Subject: **Vermont Yankee Nuclear Power Station
Technical Specification Proposed Change No. 263 – Supplement No. 33
Extended Power Uprate – Response to Request for Additional Information**

Proposed Technical Specification Change No. 263 – Supplement No. 33

Response to Request for Additional Information

Figure EMEB-B-39-1 Dryer Model without skirt 53 Hz Mode

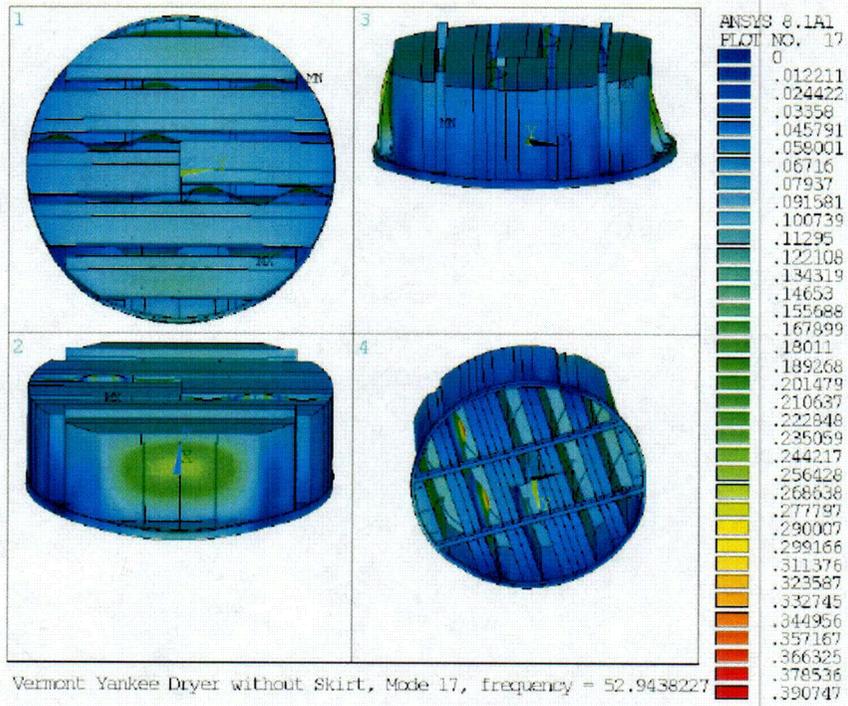
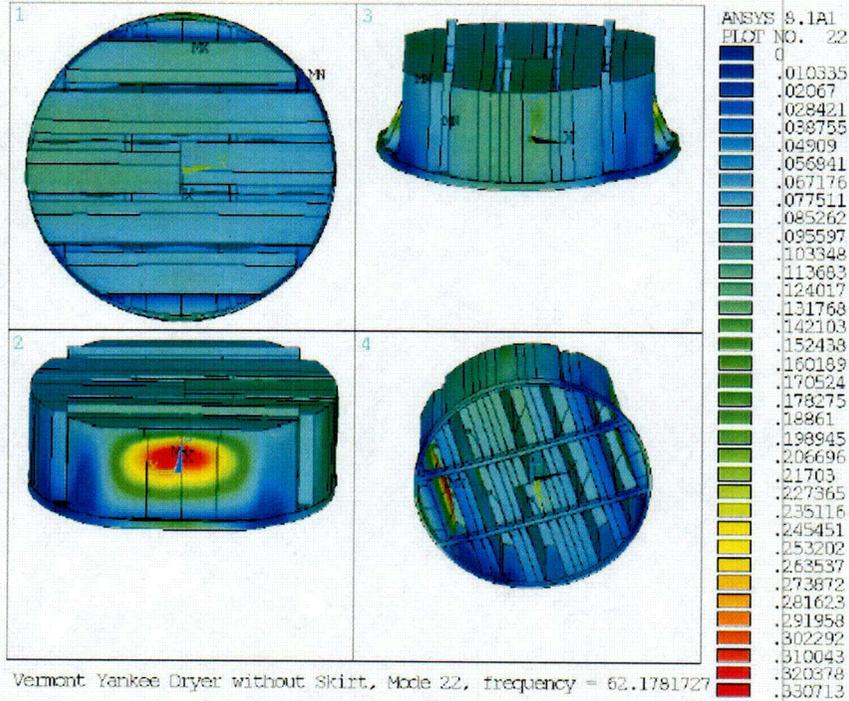
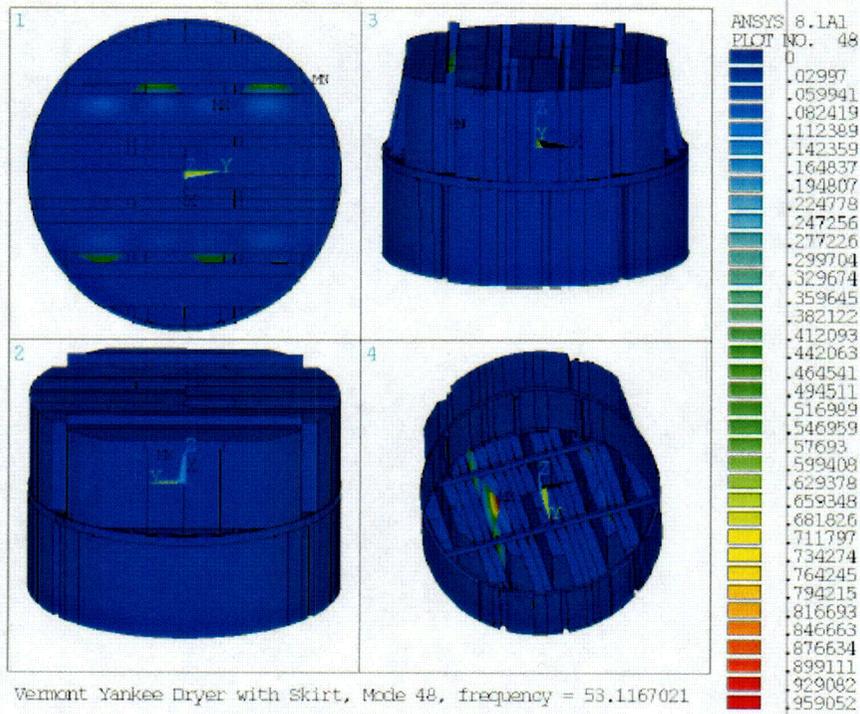
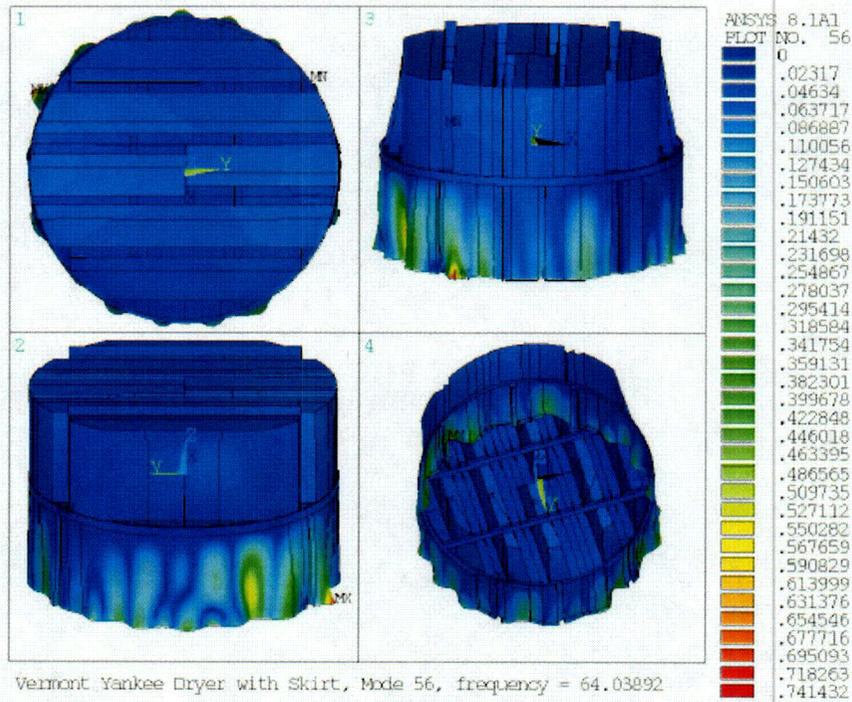
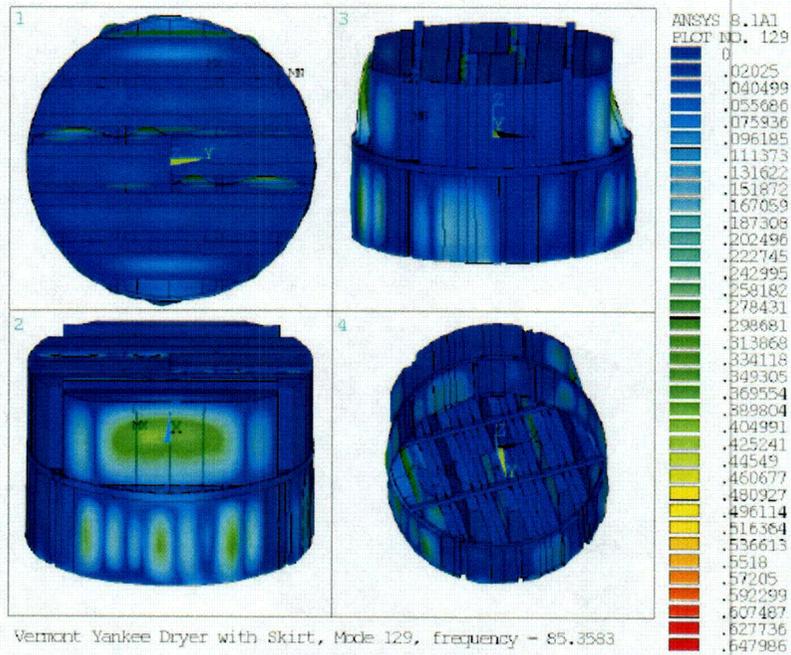
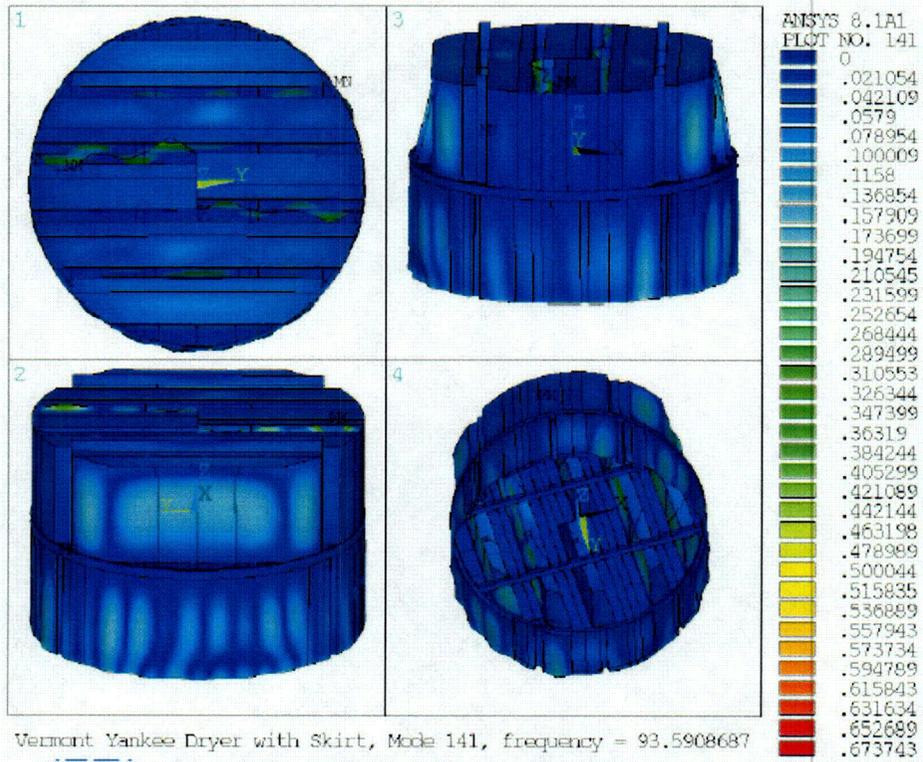
In Attachment 6 to Supplement 26, the modified dryer is shown in Figures 3.1-1 (Page 17) and 3.7.1 (Page 21) for CFD analysis and ANSYS analysis, respectively. The recent hammer test performed for a new steam dryer at Quad Cities indicated that significant coupling exists between the upper portion of the dryer and the skirt with pressure loading applied to the full dryer including the skirt. Confirm whether the full steam dryer model in the CFD and ANSYS analyses consists of both upper dryer banks, supporting ring, and the skirt. If the skirt is not included in the analysis, provide a justification.

Figures EMEB-B-39-1 through EMEB-B-39-5 demonstrate the effect on the front hood fundamental frequencies when the skirt is included in the dryer model. As shown in Figures EMEB-B-39-1 and EMEB-B-39-2, there are strong modes for the dryer front hood at both 53 and 62 Hz for the model without the dryer skirt. Figures EMEB-B-39-3 through EMEB-B-39-5 show that there are no significant modes for the front hood in this frequency range when the skirt is included in the dryer model. Figures EMEB-B-39-6 and EMEB-B-39-7 show that the first fundamental frequencies for the front hood do not appear until 85 and 94 Hz when the dryer skirt is included in the FEA model.

The VYNPS steam dryer FEA model without skirt has 234 modes from 0-200 Hz. The number of modes increases to 391 modes when the skirt is included in the model. The increased number of modes with the dryer skirt included is entirely due to the additional skirt modes. The effect of including the skirt into the dryer model to determine whether there was a significant change in fundamental frequencies in the upper dryer structure was also studied. The results of the study show that the mode shapes for the upper dryer structure components for the model without skirt are preserved for the model with the skirt. This provides evidence that there is insignificant coupling between the upper dryer structure and the dryer skirt. As an example, Figures EMEB-B-39-8 through EMEB-B-39-11 show comparisons of the modified outer hood top hood fundamental frequencies for the dryer model with and without the skirt. As discussed in the response to RAI EMEB-B-110, this location has one of the highest peak stress intensities in the VYNPS dryer. The modal displacements for the dryer top hood are insignificantly changed when the skirt is included in the dryer model.

Figure EMEB-B-39-13 – Skirt Peak Stress Intensity

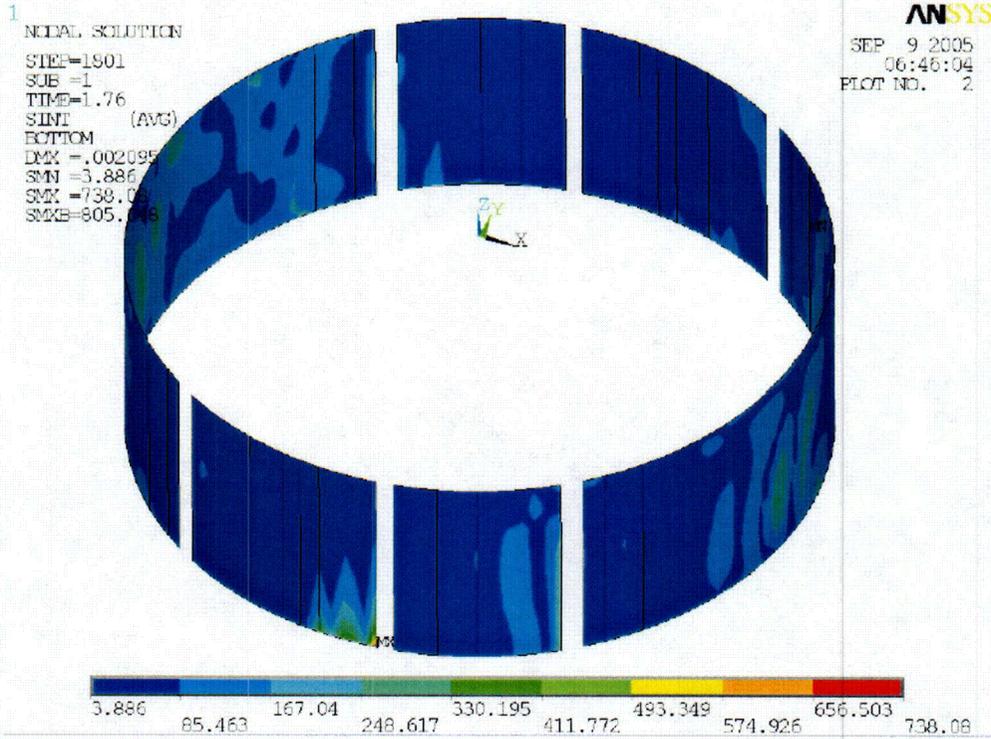
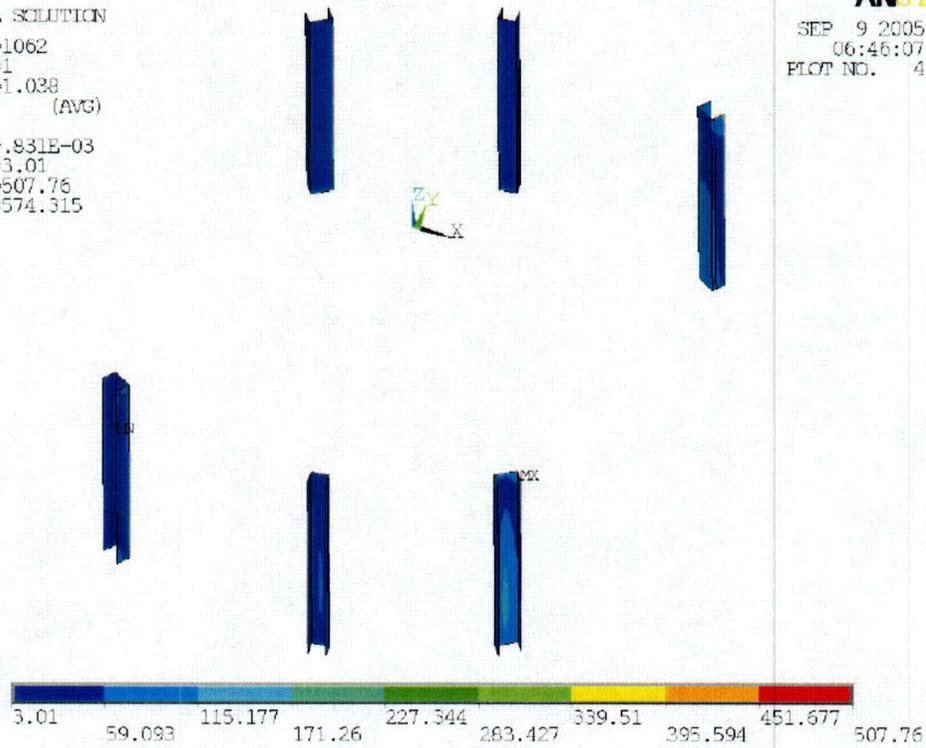
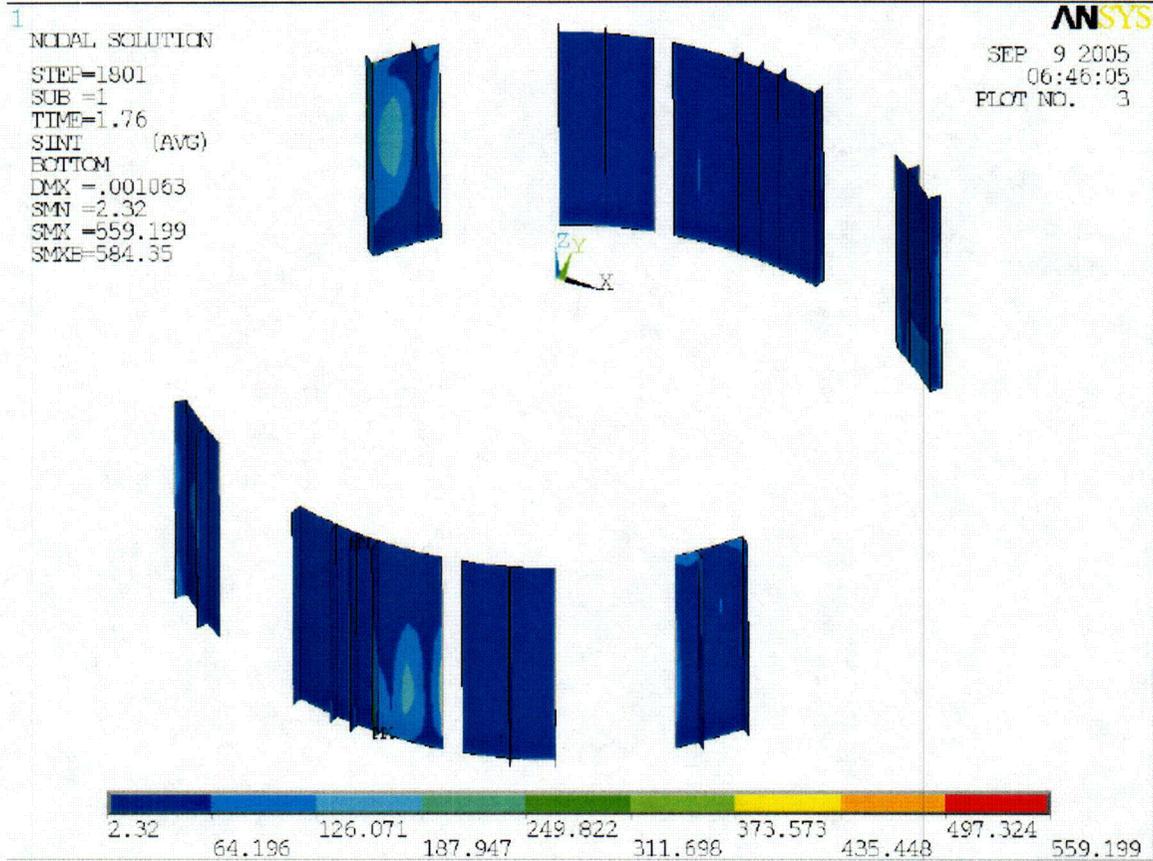
During the August 2005 audit of the VYNPS steam dryer analysis, the NRC questioned Entergy concerning the stress intensity of the dryer skirt. A time history evaluation of the VYNPS FEA model with the dryer skirt included was performed, using the ACM loads as input, in order to provide a quantitative response. Figure EMEB-B-39-12 shows a graphical representation of the FEA model with the dryer skirt included. The key components of the dryer skirt are the skirt plates, the interior drain channels and the guide rod/support lug channels. A damping value of 1% of critical damping was used in the time history analysis. Plots of the peak stress intensity are shown in Figure EMEB-B-13 through EMEB-B-15. The results of the time history analysis are shown in Table EMEB-B-39-1. The steam velocity inside of the dryer skirt is about five ft/second. Flow velocity on the outside of the steam dryer skirt is essentially zero. Therefore, hydrodynamic oscillating loads on the dryer skirt are considered insignificant. The dryer skirt stresses are not the governing stresses for determination of the VYNPS Level 1 and 2 power ascension performance criteria spectra.

In summary, a stiffer model would reduce CFD stress and increase ACM stress. Entergy has considered a +/-10% frequency uncertainty in the analysis. The VYNPS Level 1 and 2 power ascension performance criteria spectra will be conservatively reduced to account for ACM and CFD load uncertainty. Based on the factors described in Exhibit EMEB-B-143-1, the VYNPS performance criteria spectra would require re-evaluation of the dryer at strain gage readings at level equivalent to 10% of the PSD amplitude experienced by QC2. Further sensitivity analysis is not warranted until a discernable VYNPS signature is observed. Entergy expects to use the finite element model with the dryer skirt included for the performance of any additional finite element analysis that may be required during EPU power ascension.
